Camden Town Hall

Implications of heritage doors not being upgraded on the fire strategy

Basement - Door Coordination Plan
Heritage Fire Doors

CTH-PUR-B0-DR-31-A-5600

CTH-PUR-L01-DR-31-A-5602

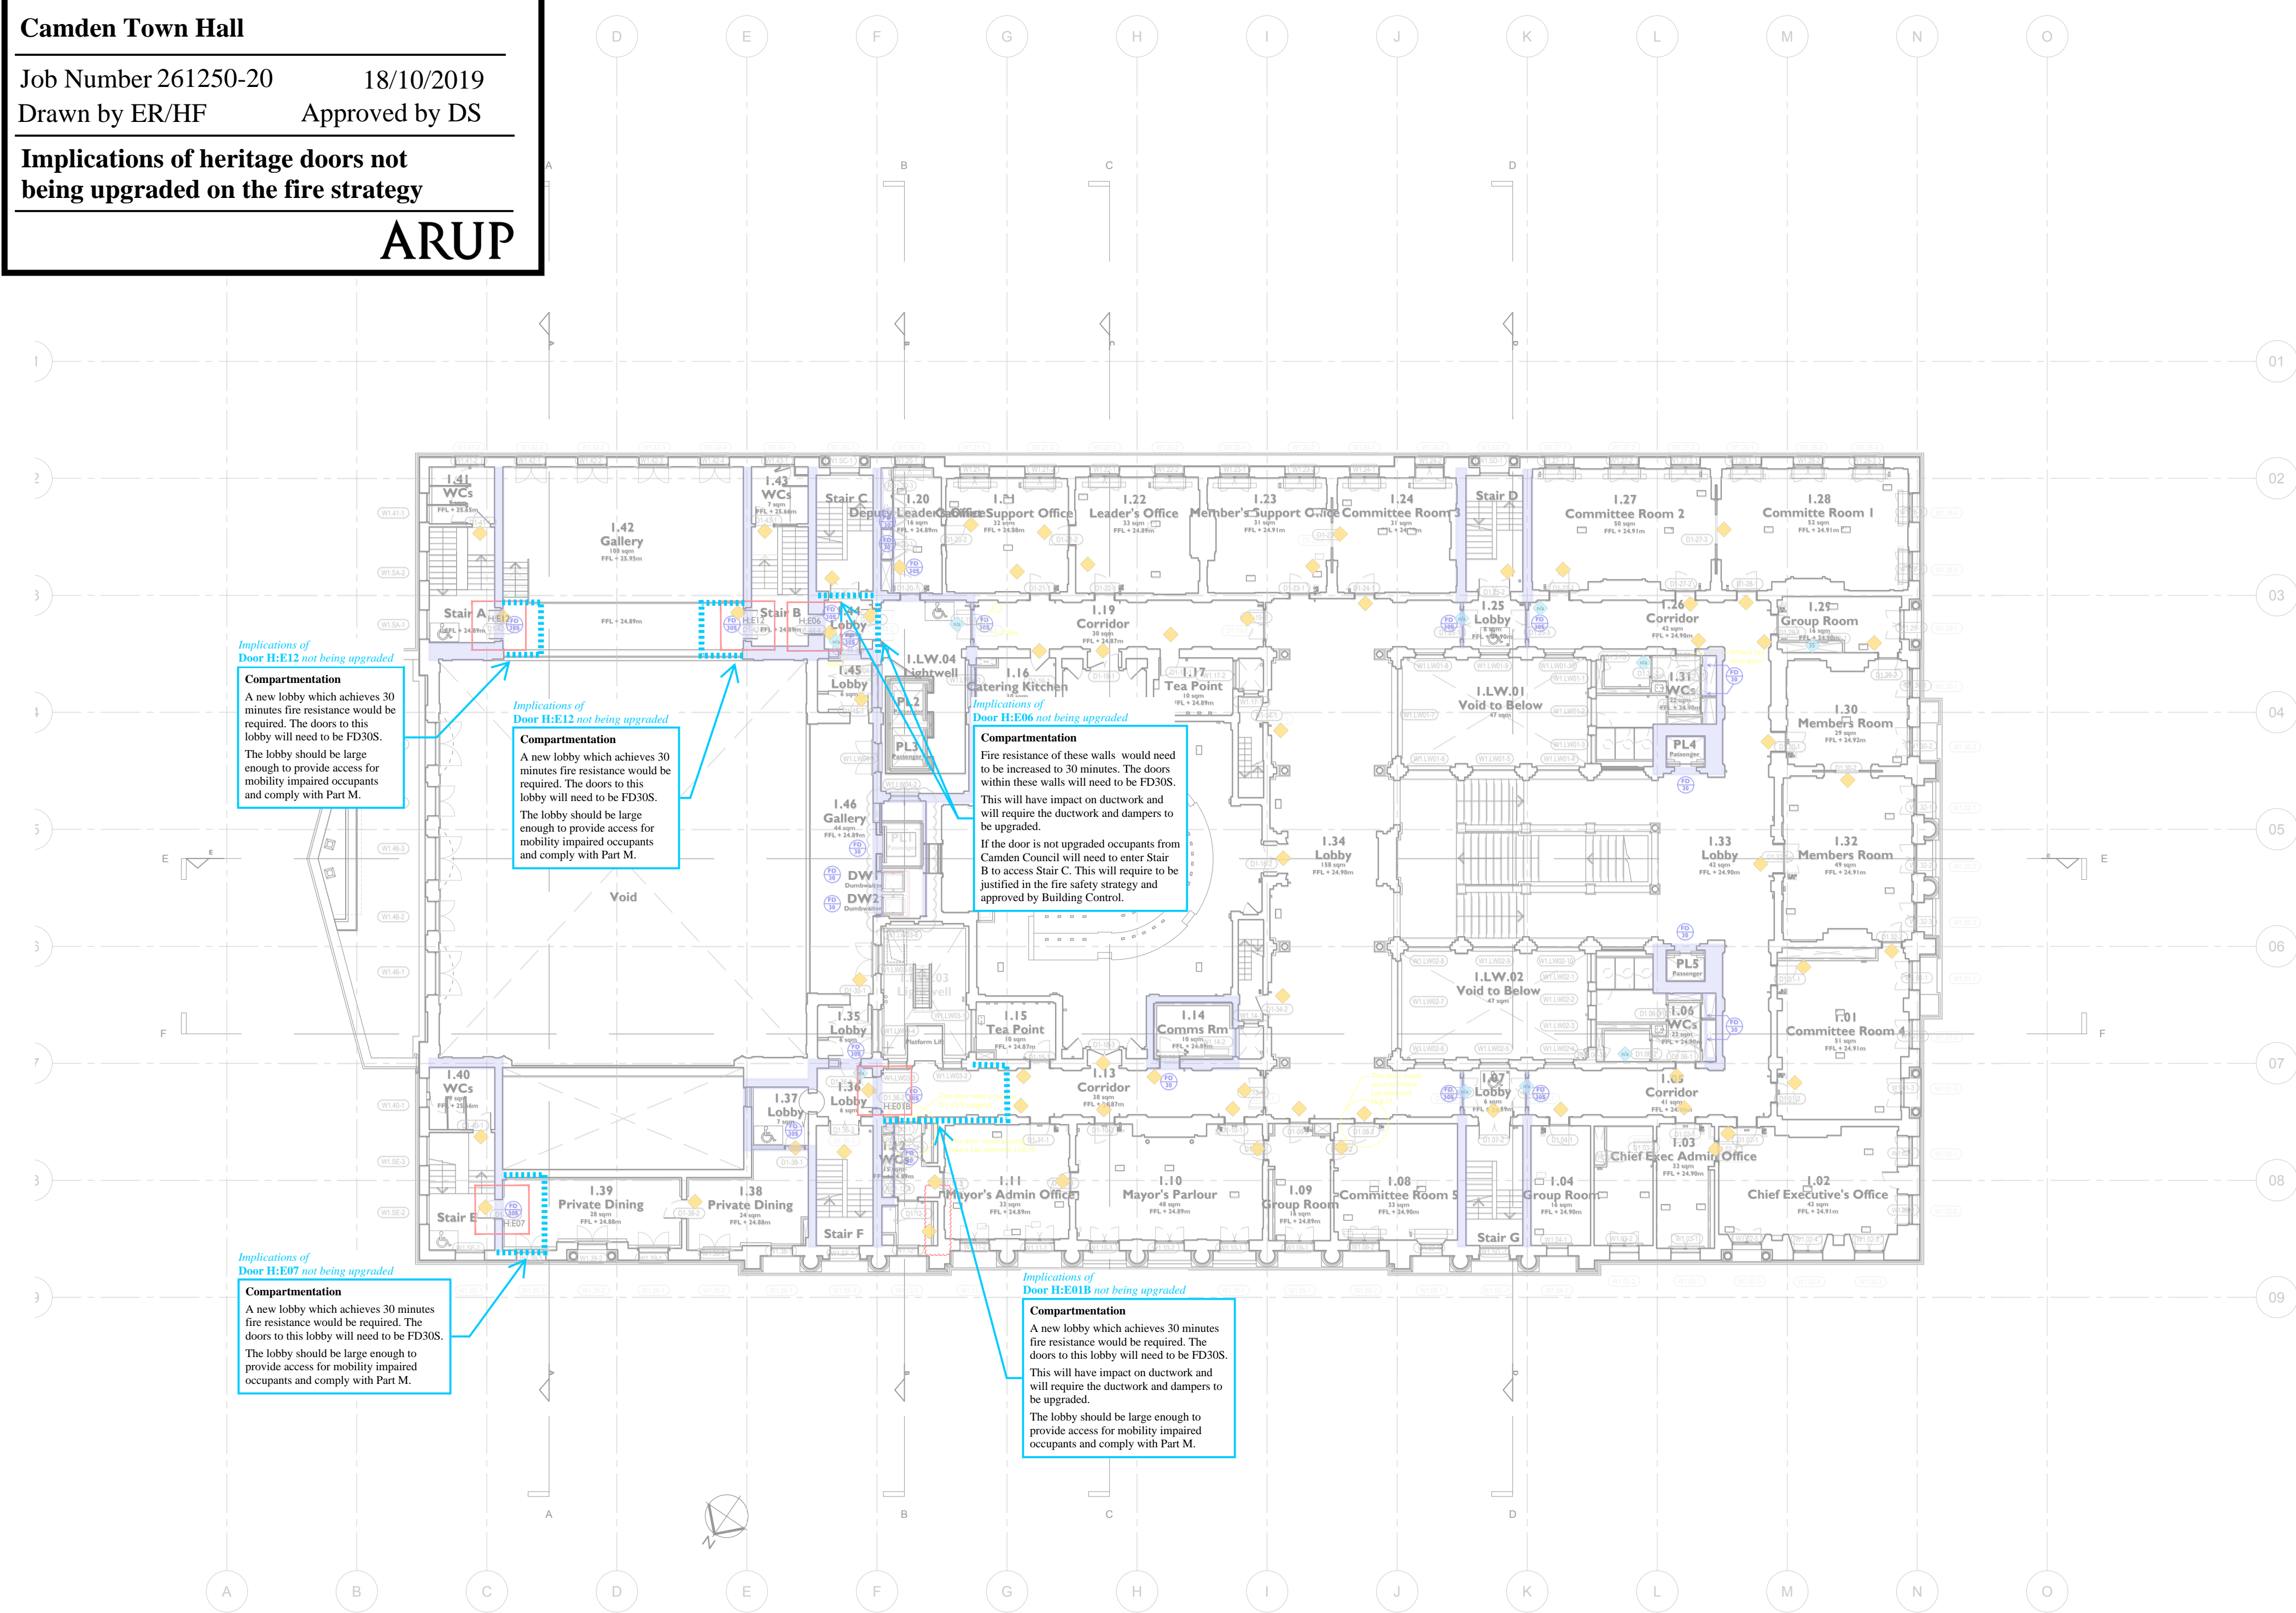
Assume always open when building open.
	Assume manual opening.
	Assume no automation.
	Council policy on automatic door to meeting room. Nice to have.
	Council policy on automating doors to accessible WC cubicles.
	Preferable if completely new door has 750mm clear width through one open leaf
	Prefer single door 900mm clear width automated.
	Assumed Camden Centre tenant will have managed means of escape procedure.
	Not in use.
	Doors currently left open. If they are closed in future (as per security strategy) they need automation.
	Council to reconfirm that only side doors being automated is acceptable (I understand main central door is difficult to automate.
	Council to confirm it is acceptable for there to be management strategy to assist wheel chair user to access wheel chair refuge, or automate doors.
	Tenant needs to have management strategy to open door of automate.
	Not in use.
	Can these doors be removed?

Automatic doors on activation of fire alarm. Purcell to confirm details of doors for comments on accessibility.
	These new double doors are too narrow. Can they be 1.5 or 1 door leaf?
	These doors need to be automated, to assist wheel chair users reaching refuges, or management strategy required.
	Not in use.
	Should platform lift doors be fire rated?
	Not in use.
	Not in use.
	Not in use.
	Not in use.
	Need to see details of terraces.
	Not in use.
Acoustic Key	
	Acoustic rating for newly proposed door, Rw30
	Acoustic rating for newly proposed door, Rw35
	Acoustic rating for newly proposed door, Rw40
	Newly proposed door, no acoustic rating required
	Doorset retained (Pending review)
	Recommended 35Rw
	Recommended 40Rw

DRAWING NO. CTH-PUR-L02-DR-31-A-5604

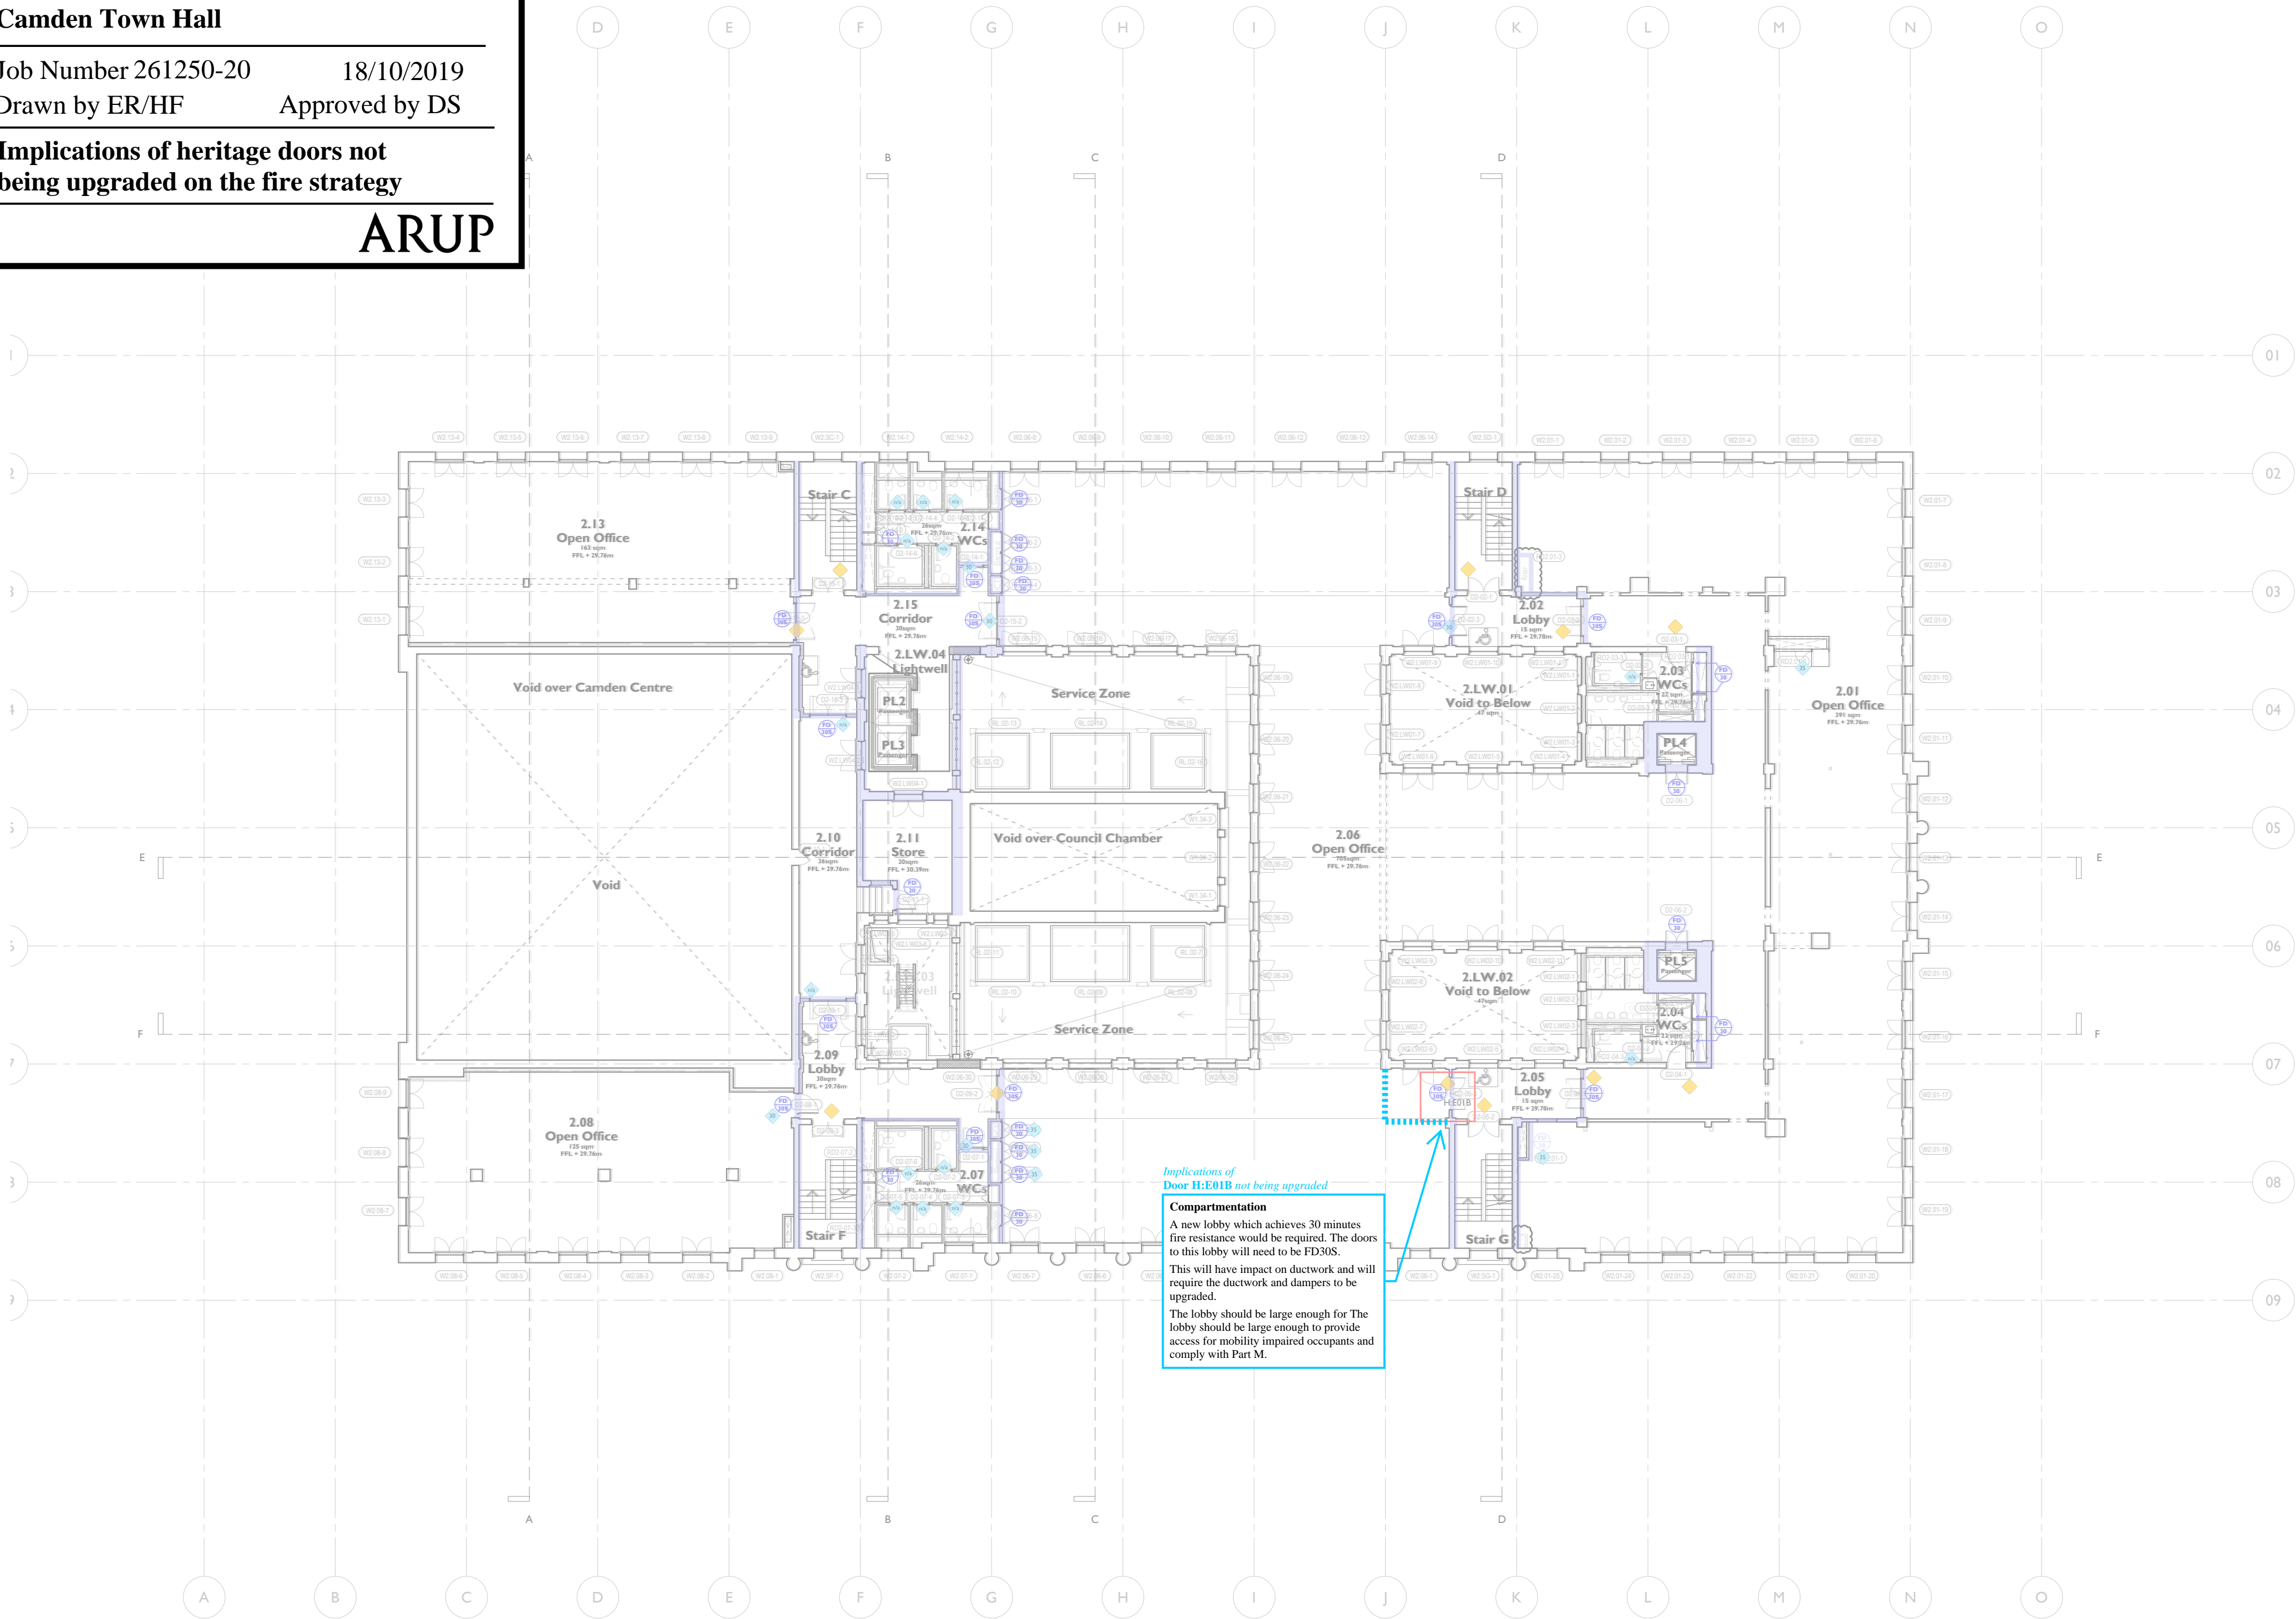
Access notes from Jane Toplis mark-up of 30.07.19	
01	Assume always open when building open.
02	Assume manual opening.
03	Assume no automation.
04	Council policy on automatic door to meeting room. Nice to have.
05	Council policy on automating doors to accessible WC cubicles.
06	Preferable if completely new door has 750mm clear width through one open leaf
07	Prefer single door 900mm clear width automated.
08	Assumed Camden Centre tenant will have managed means of escape procedure.
09	Not in use.
10	Doors currently left open. If they are closed in future (as per security strategy) they need automation.
11	Council to reconfirm that only side doors being automated is acceptable (I understand main central door is difficult to automate.
12	Council to confirm it is acceptable for there to be management strategy to assist wheel chair user to access wheel chair refuge, or automate doors.
13	Tenant needs to have management strategy to open door or automate.

14	Not in use.
15	Can these doors be removed?
16	Automatic doors on activation of fire alarm. Purcell to confirm details of doors for comments on accessibility.
17	These new double doors are too narrow. Can they be 1.5 or 1 door leaf?
18	These doors need to be automated, to assist wheel chair users reaching refuges, or management strategy required.
19	Not in use.
20	Should platform lift doors be fire rated?
21	Not in use.
22	Not in use.
23	Not in use.
24	Not in use.
25	Need to see details of terraces.
26	Not in use.
Acoustic Key	
	Acoustic rating for newly proposed door, Rw30
	Acoustic rating for newly proposed door, Rw35
	Acoustic rating for newly proposed door, Rw40
	Newly proposed door, no acoustic rating required
	Doorset retained (Pending review)
	Recommended 35Rw
	Recommended 40Rw
